Swan_soundbar_DVT_MIC_Soldeirng

ALT Co., Ltd.

Issued Date 2021.08.11

- X-ray image – DVT3 MIC PCBA
 - NG

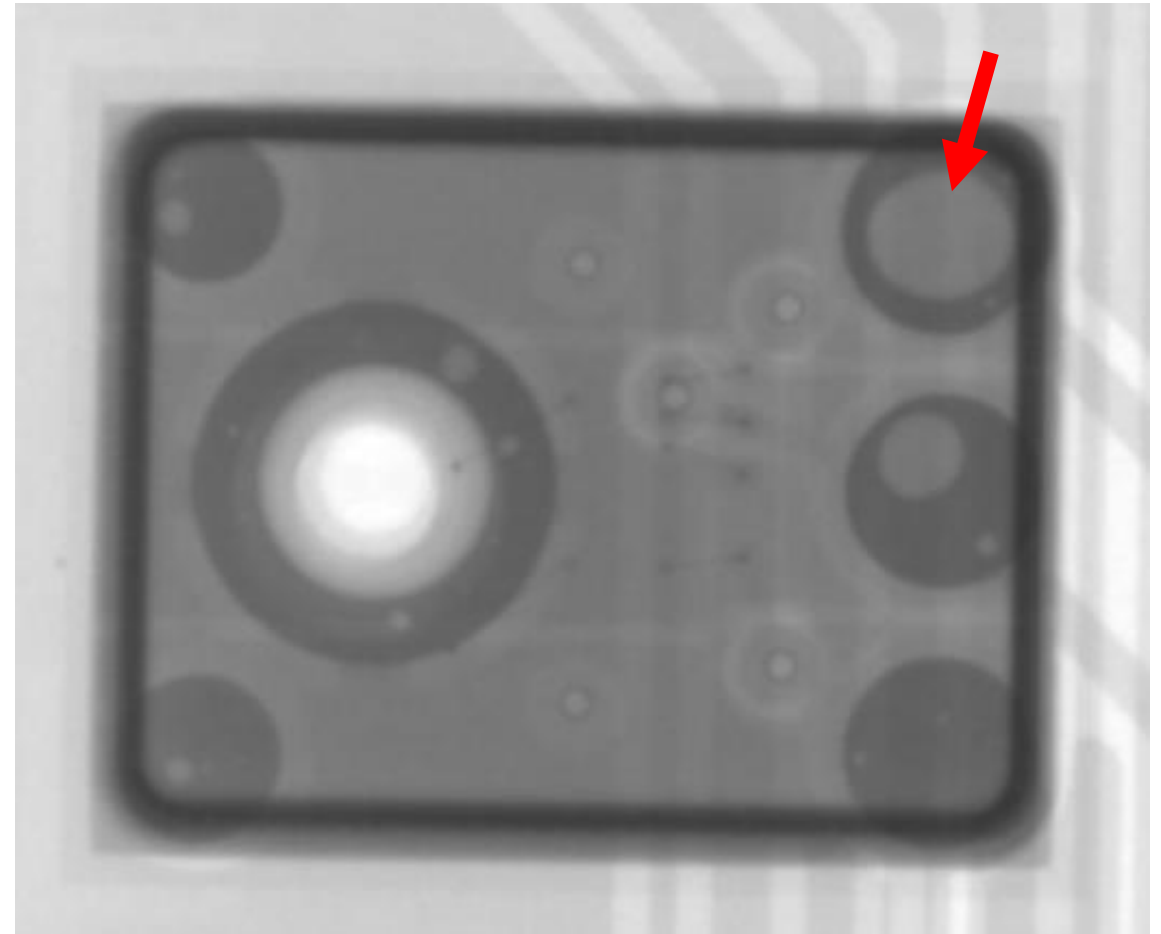
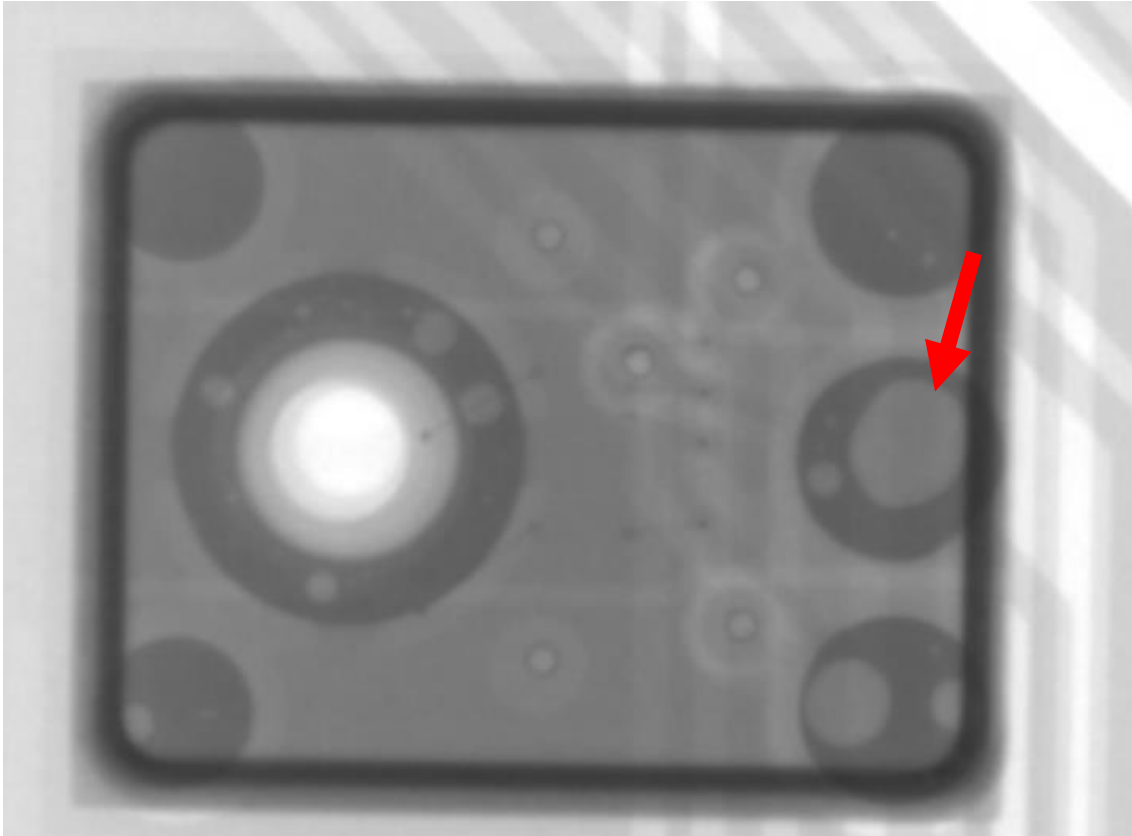
- One of MICs on MIC PCBA signal pin soldering condition is NG
 - The bga void is larger than 25% over.
- This void is making a negative effect on the reliability of the board
 - In particular, soundbar vibration adversely affects reliability of MIC function.
- ALT will follow IPC-A-610 standard.
 - ALT will add the special inspection item for Mic soldering conditions on manufacturing specification of SWAN
 - Fii manufactured MIC pcba was problematic with each build.

- Factory Action item (210403)
 - report the optimum soldering conditions for MIC PCBA
 - i.g. Metal mask(stencil), Screen printer, reflow profile,, etc
 - Report the test and validation plan for MIC soldering conditions
 - O-ring, solder balls, Void, etc..
- Factory Action item (210811)
 - The improvement plan was submitted, but as a result, no improvement was made.
 - ALT is not agree this defected soldering quality for mass production
 - FII should be submit the validation report before mass production.
